PLANNING COMMISSION STAFF REPORT

**Our Lady of Guadalupe Church
Minor Subdivision #PLNSUB2008-00698
Planned Development #PLNSUB2008-00869
Conditional Use #PLNPCM2008-00697
715 West 300 North
May 27, 2009**

**Attachment B:
City Departmental Comments**

PROPOSED SITE PLAN

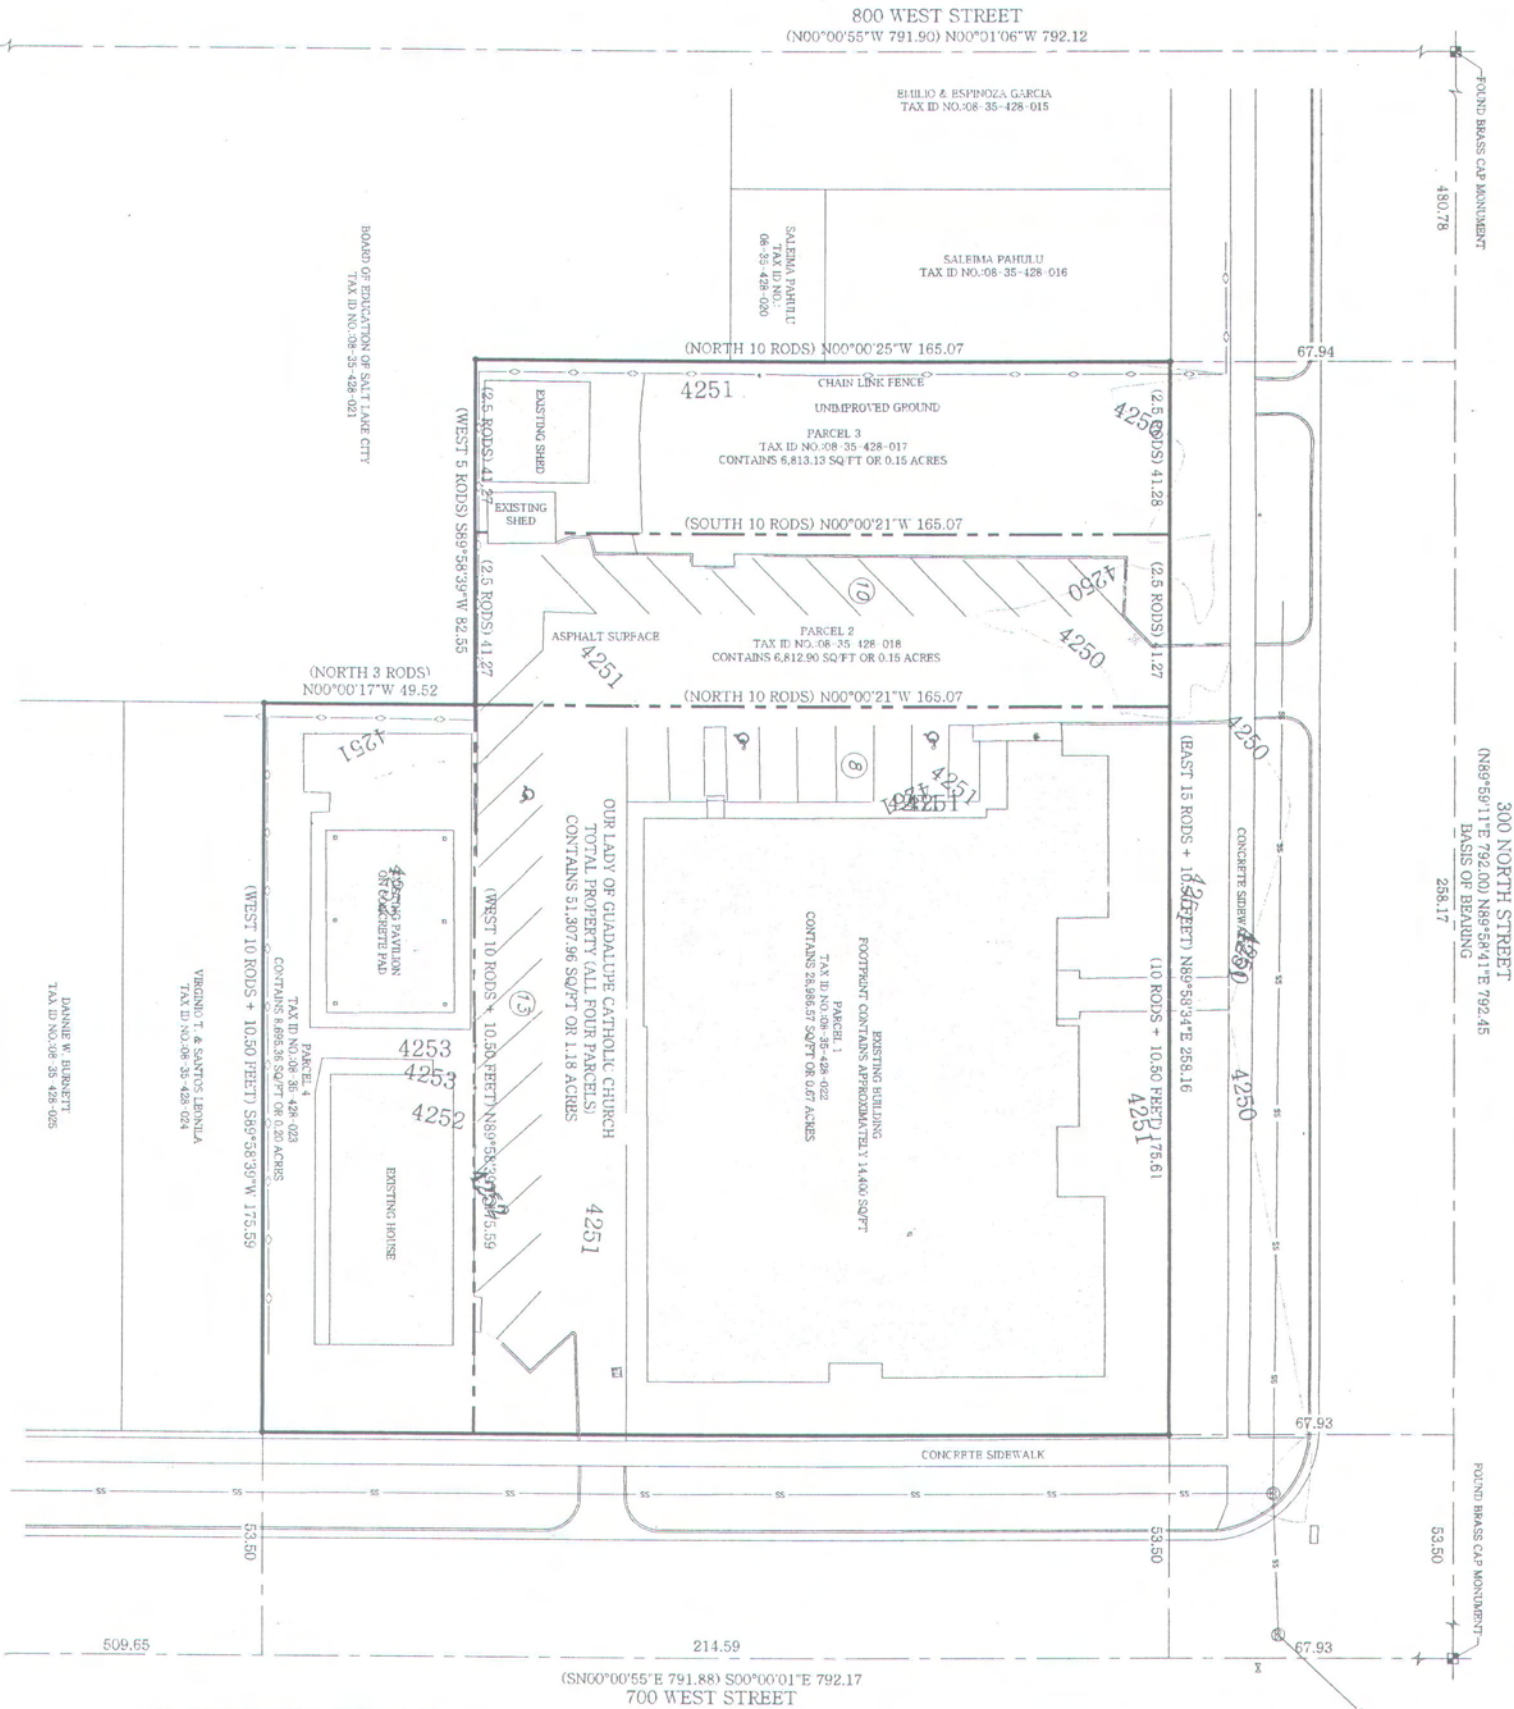
Subdivision plat required-minor subdivision. Site plan required. Clarify drive approach issue on 700 West. Site plan is incorrect. At the time of application for approval, an inventory of the condition of the existing street and/or access-way improvements will occur. At that time, the condition of said improvements will be determined, and any sub-standard improvements (curb, gutter, sidewalk, asphalt paving, etc.) will be required to be either repaired or replaced as a condition of approval of the project. Public Way Permit to required for project completion. Licensed, bonded and insured Contractor to obtain permit to install or repair required street improvements.

The revisions shown on the site plan for 257 South, to relocate the existing driveway & front yard parking and landscaping.
